EXECUTIVE SUMMARY

TO: Board of Directors, Columbia 9-1-1 CD
CC: Mike Fletcher
FROM: Michael W. Peterkin, General Counsel
DATE: September 18, 2023
RE: Meissner Shelter Construction Defect

COLUMBIA 911 MEISSNER SITE
DAY WIRELESS SYSTEMS
67154 LOOKOUT ROAD
DEER ISLAND, OR

1 FOUNDATION PLAN 1/4"=1'-0"

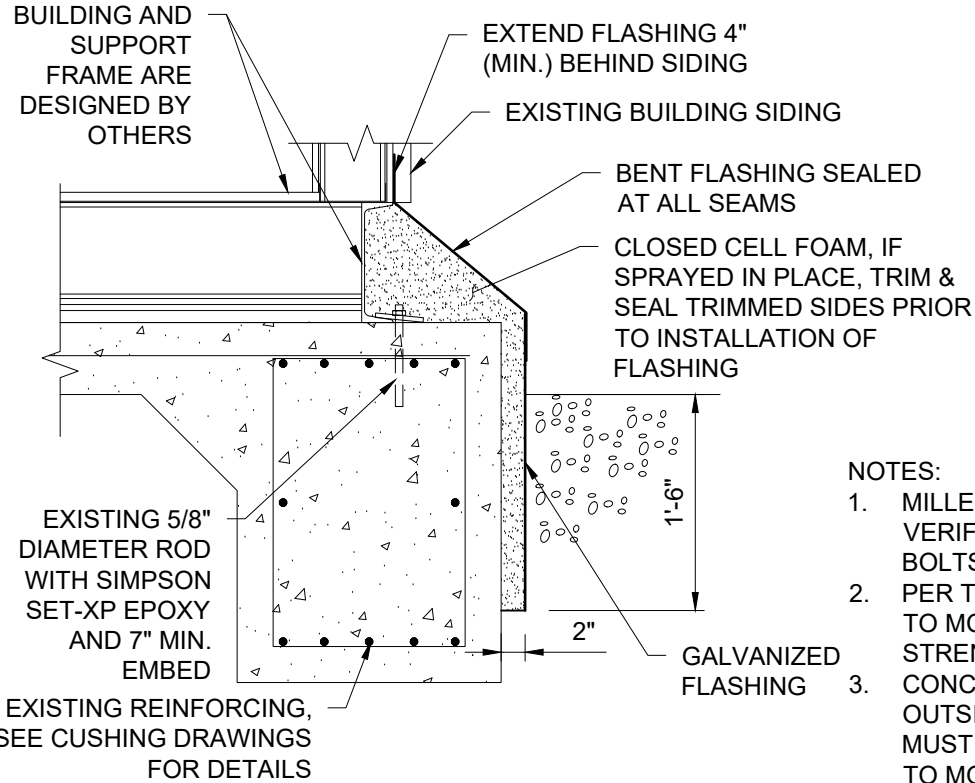
I accept the alternative submitted design provided by Day Wireless’s engineer. Please note the Carlson’s average for 28 day break was including the 7 day break which skewed the average for 28 days.

Day Wireless’s engineer Miller Engineer addressed the current concrete strength in the calculations of 28 day and 56 day (2 breaks at 2700 plus) utilizing 2500 psi in the calculations for anchors, they added additional anchors total of 12 for the shelter. In regards to the durability of the concrete from freeze thaw I approve the closed cell foam and residing the walls and closed cell foam. The additional new siding and foundation insulation assembly will provide a solution equal to or better for the structure in whole as the siding will provide a longer life of the prefabricated shelter as typical the foundation will outlast the typical life of a prefabricated shelter.

I agree Day Wireless should provide an additional 10 year warranty and cover the associated costs of the modifications you mention below. (sic in passim.)
